**M24512-DF package mechanical data modifications**

**Silicon identification**

This errata sheet applies to the M24512-DF, which is 512Kbit serial I<sup>2</sup>C bus EEPROMs, and specifically to the device delivered in 8-bump wafer-level chip-scale packages (WLCSP).

Figure 2. D and E front side view

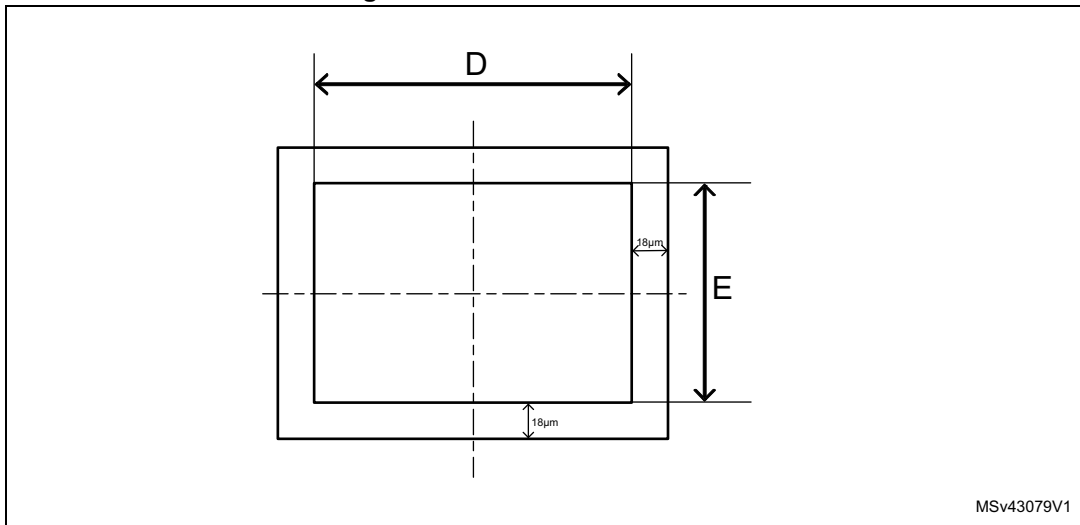
- The D and E values in the M24512-DF datasheet correspond to front side view (ball side), instead of back side view (marking side view).  
[Table 2](#) and [Table 3](#) report the data for the front and back view, respectively.

Symbol	Millimeters			Inches		
	Min	Typ	Max	Min	Typ	Max
D	-	1.271	1.291	-	0.0500	0.0508
E	-	1.937	1.957	-	0.0763	0.0770

Figure 3. D and E back side view

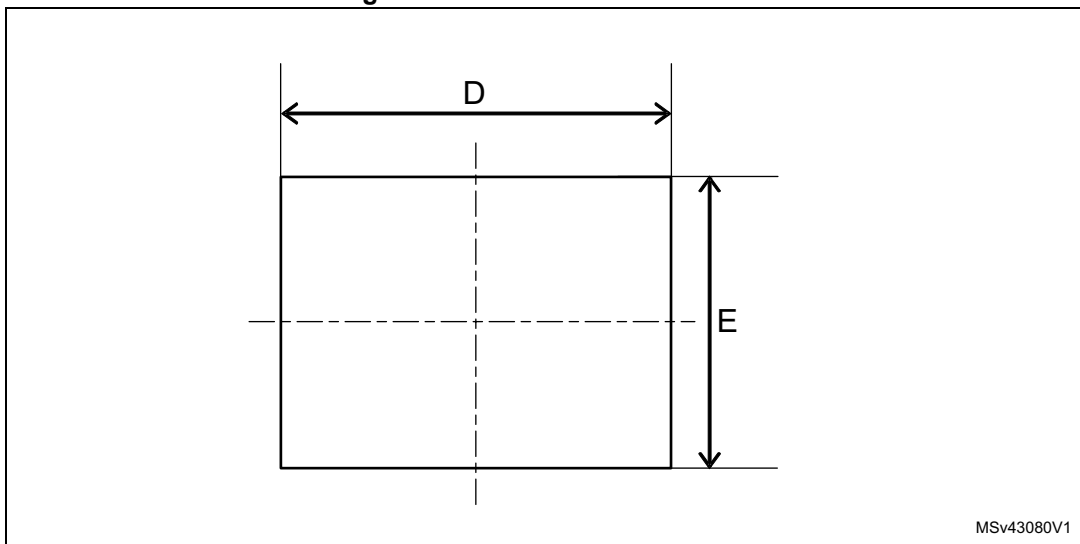
This document refers to the changes in dimensions D and E (see [Figure 3](#)) described in the M24512-DF datasheet, in tables detailing the dimensions of the WLCSP 8-bump package.

D and E values must be modified to correct the following mistake:

Symbol	Millimeters			Inches		
	Min	Typ	Max	Min	Typ	Max
D	-	1.289	1.309	-	0.0507	0.0515
E	-	1.955	1.975	-	0.0770	0.0778

Figure 4. D or E side view

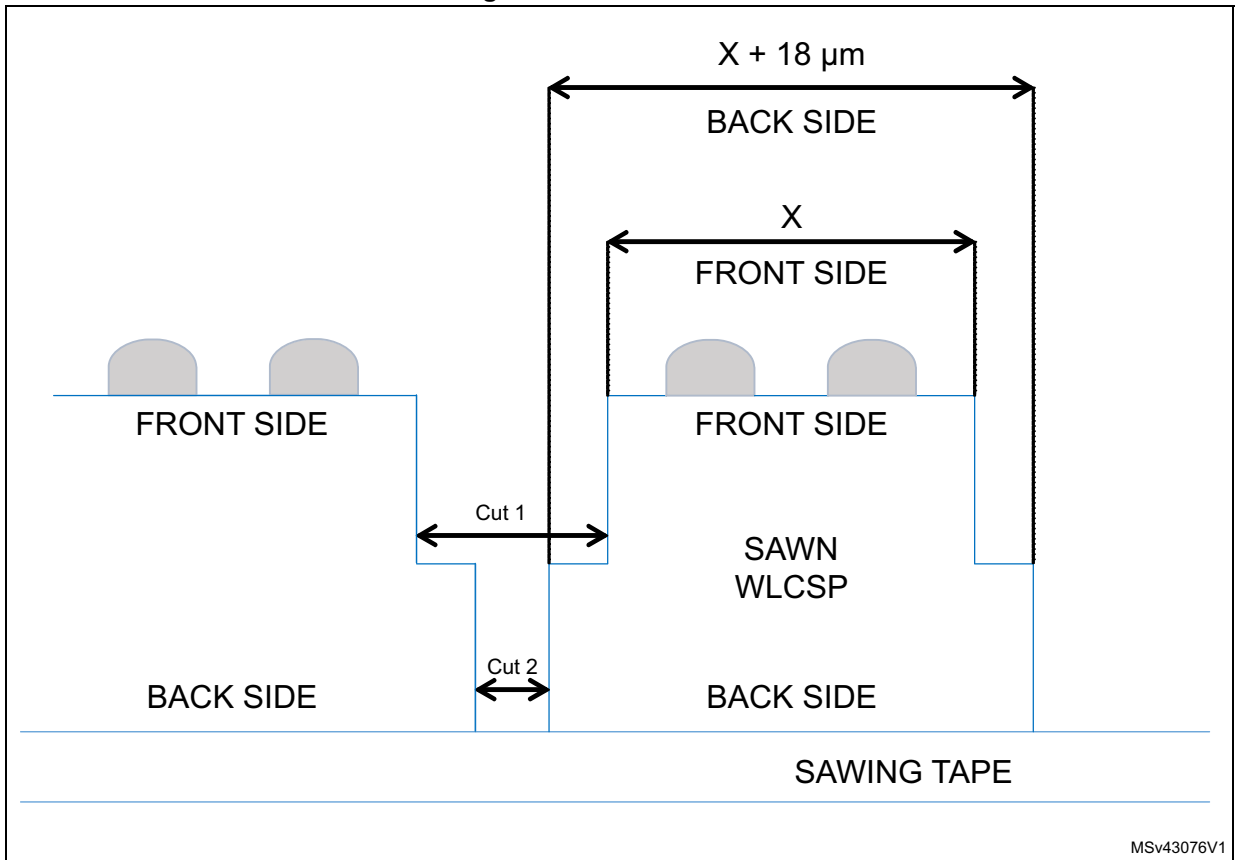
The difference between back side and front side dimension is 18 µm (0.018 mm). This difference is due to the two-step sawing process, where cut 1 and cut 2 are performed with blades having different thicknesses (see [Figure 4](#) in which X represents D or E and it has the same value and tolerance).
